Appendix 2-C

Summary of Written Comments and Responses

CWC Figure 6: Arsenic Concentrations in Public Water System Wells, Monterey, Langley East Side Subbasins (Red dots = >10 ppb, Orange = 5-9.9 ppb, Yellow = 0.6-5.9 ppb, Green= non-detect)

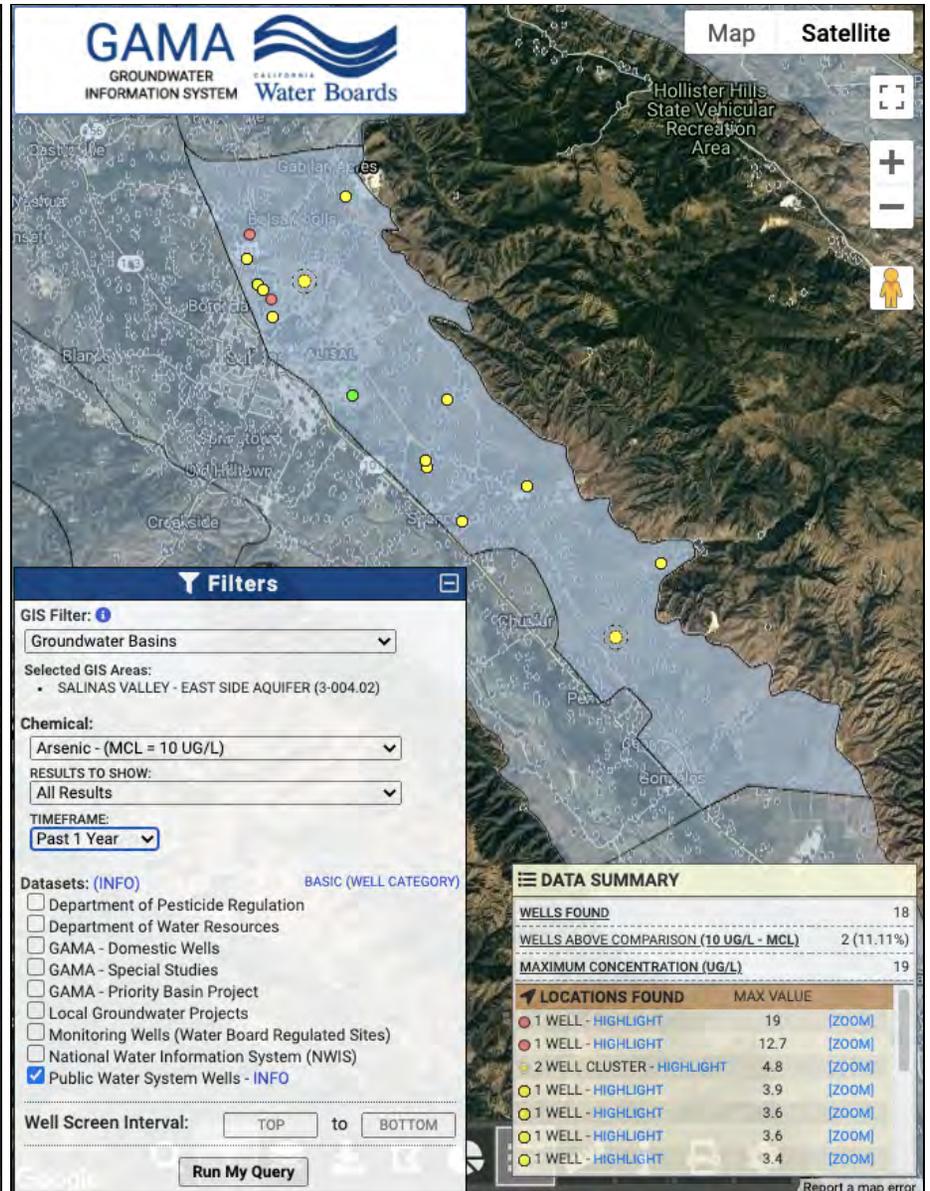
- **Forebay Subbasin:** While arsenic is less common in the Forebay than in the Langle, Monterey, and East Side Subbasins, our review of the Monterey County Health Department data indicates that 17 state or local smalls had arsenic at levels above 1 ppb in the 2015-2017 time period, and at least two of these had levels above the MCL. See CWC Figure 5 (page 8) which illustrates trends in one of the out-of-compliance small water systems, Metz Road Water System #4. In addition, three systems monitored by Monterey County as part of their Local Primacy Program for public water systems serving 15-199 connections had hexavalent chromium detections of 2.8 ppb, 3.4 ppb, and 2.1 ppb in the 2014-2017 timeframe.
